TO: Burlington City Council
FROM: City Hall Park Design & Project Management Team
RE: Evolution of Tree Plan for & Alternative Interim Concept for Public Gathering Space
DATE: June 20, 2018

Evolution of City Hall Park Tree Plan

Evolution of City Hall Park Tree Plan: DRB Process

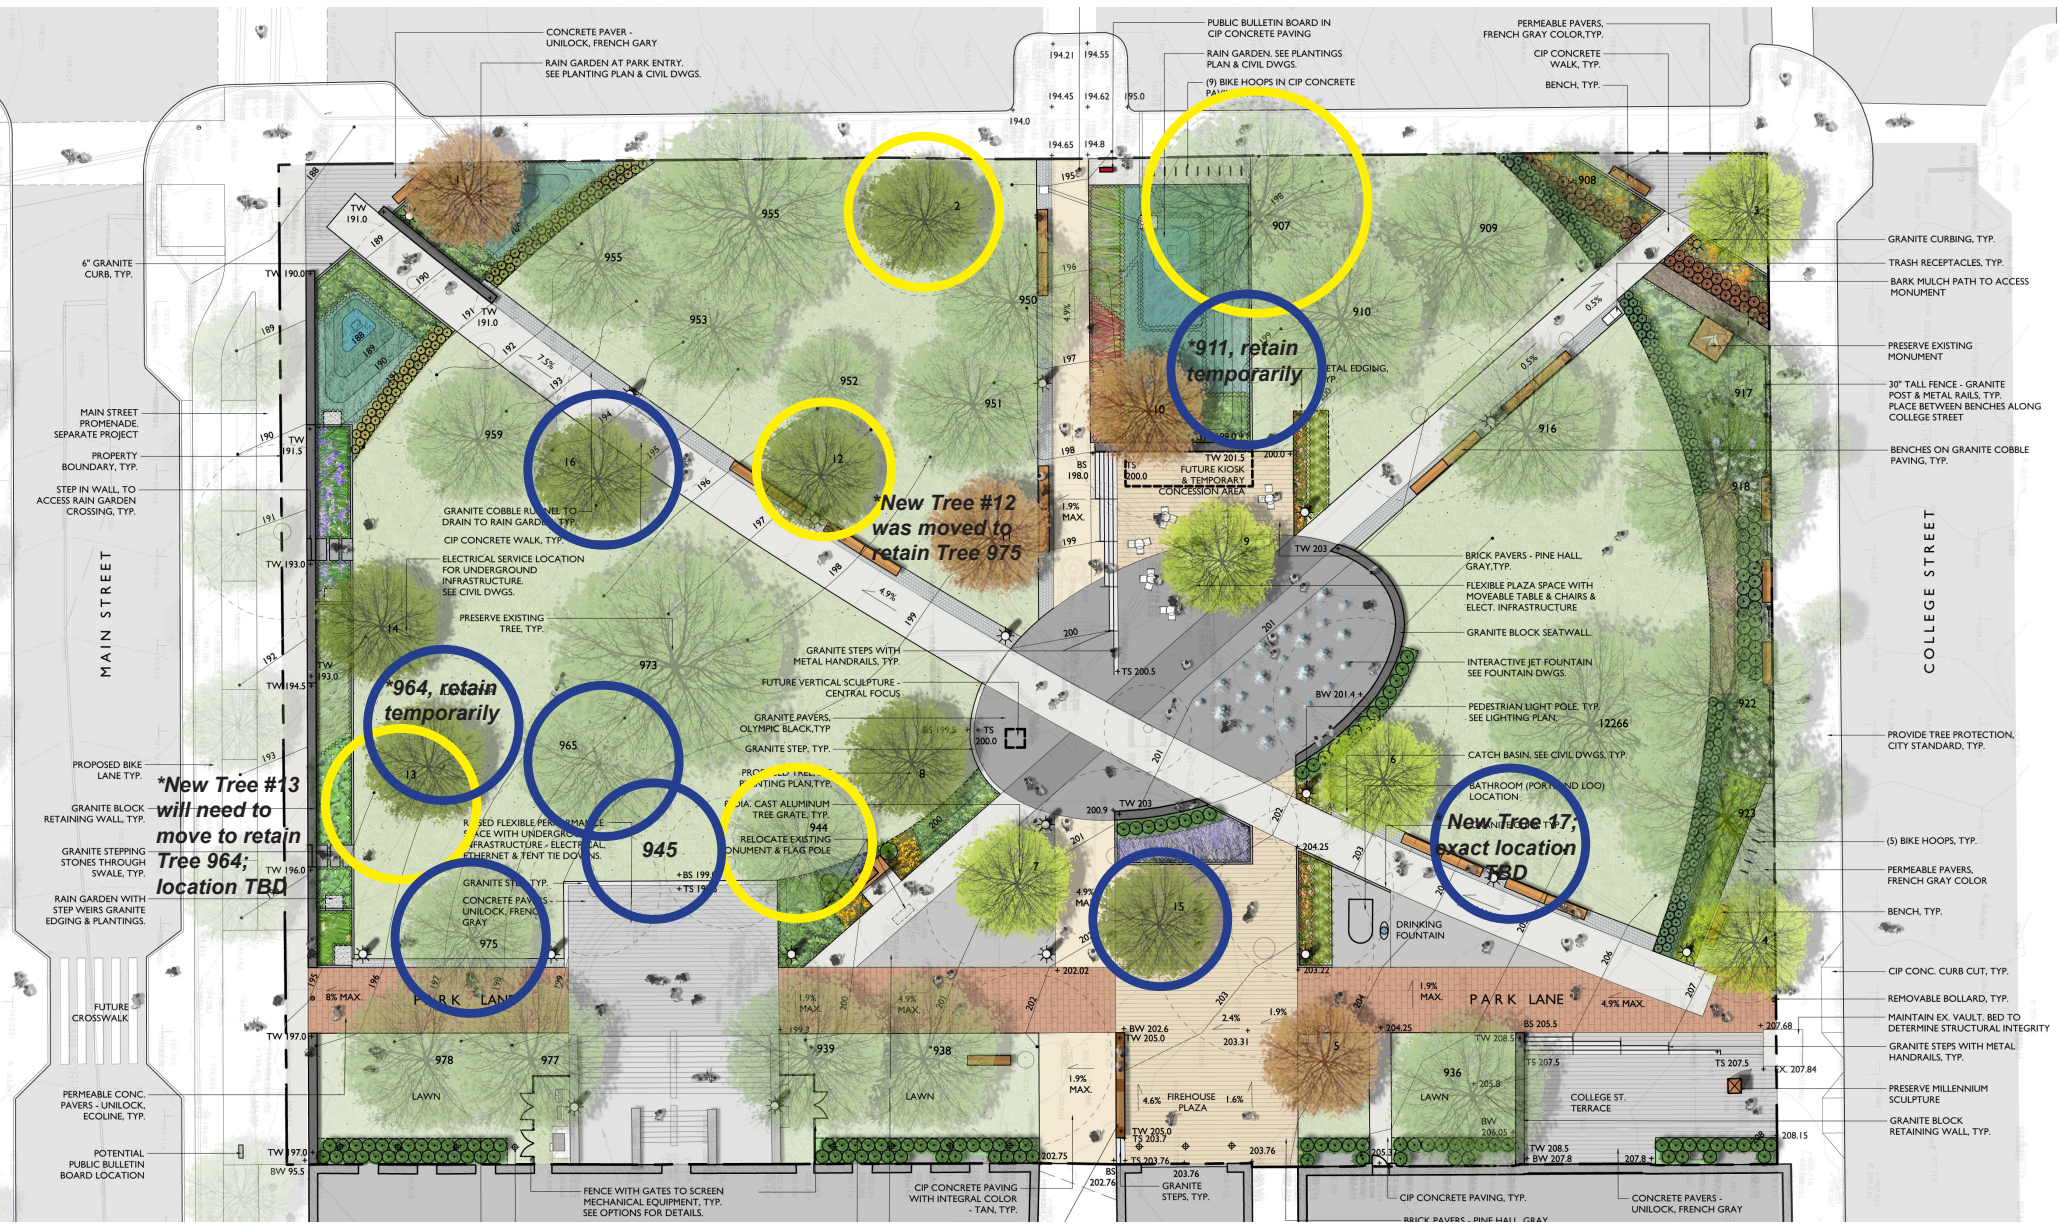
Based on public testimony during the DRB process, two additional existing trees (907, 944) were added back into the plan, and two additional new trees were added to the plan (2 and 13; 12 was relocated from its original proposed location where 907 stands). **Public feedback resulted in 4 additional trees in the plans during the DRB process for a total of 38 trees.**

***New Tree #2 was moved to retain Tree 907**

4 additional trees (3 added & 1 retained) as a result of public input during DRB process

Plan provided for June 12 Ad Hoc Meeting: rectangular space, 3 of 6 Crab Apples retained; views from east and west

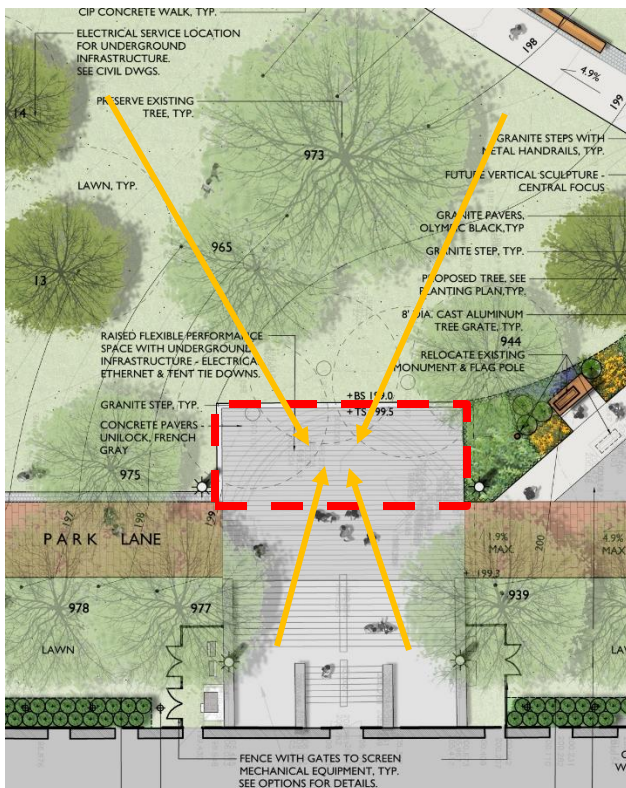
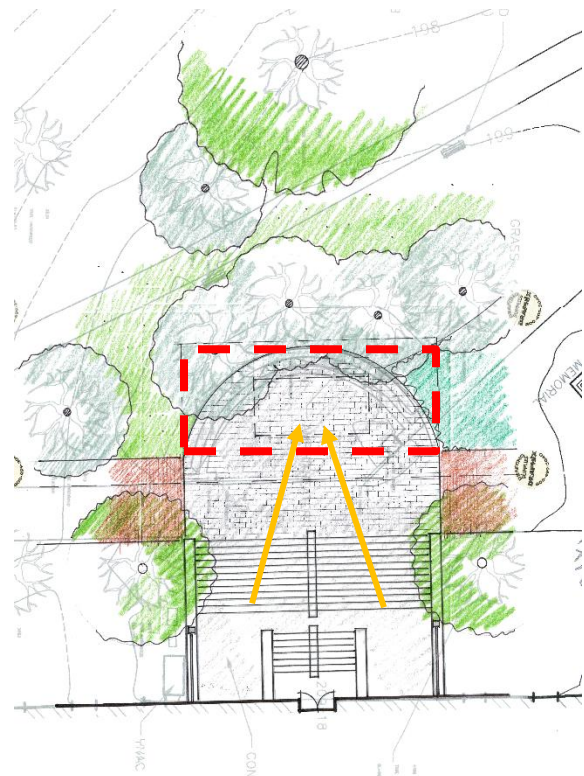
The following images provide a comparison of this space from the DRB approved plan, which includes some of the changes to the tree plan prior to the last Ad Hoc Committee meeting, to the alternative semi-circle concept. These images help illustrate how the grade and location of trees in the current plan allow it to be more integrated with the lawn to the west, versus how the space would be below the grade of and isolated from the lawn to the west if the trees are retained.

Section of the gathering space if tree 942, 945, and/or 976 were to be retained; the space is now located below the grade of the lawn to the west, and enclosed by trees which limit its visibility from the lawn.

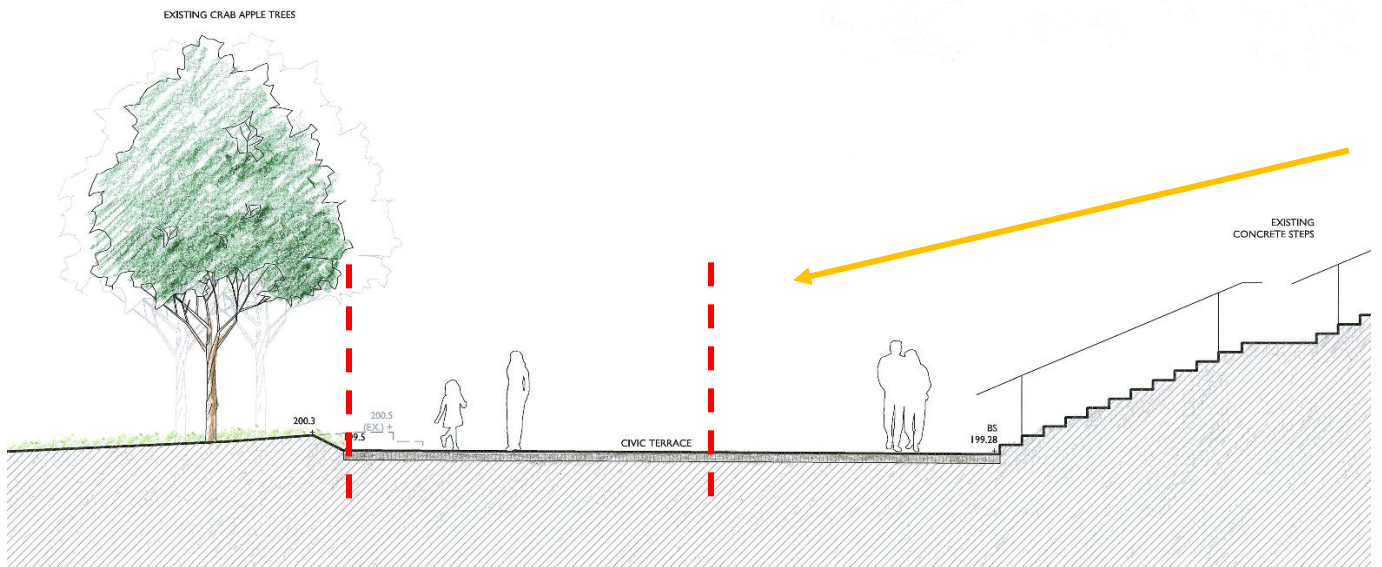
- If trees 942 and 976 were also retained, there is a risk that the space would never be retrofitted to the rectangular configuration due to the long potential life span of crab apple trees. The semi-circular

configuration reduces the utility of a design feature that was meant to accommodate greater programming options, which was responsive to extensive public input.
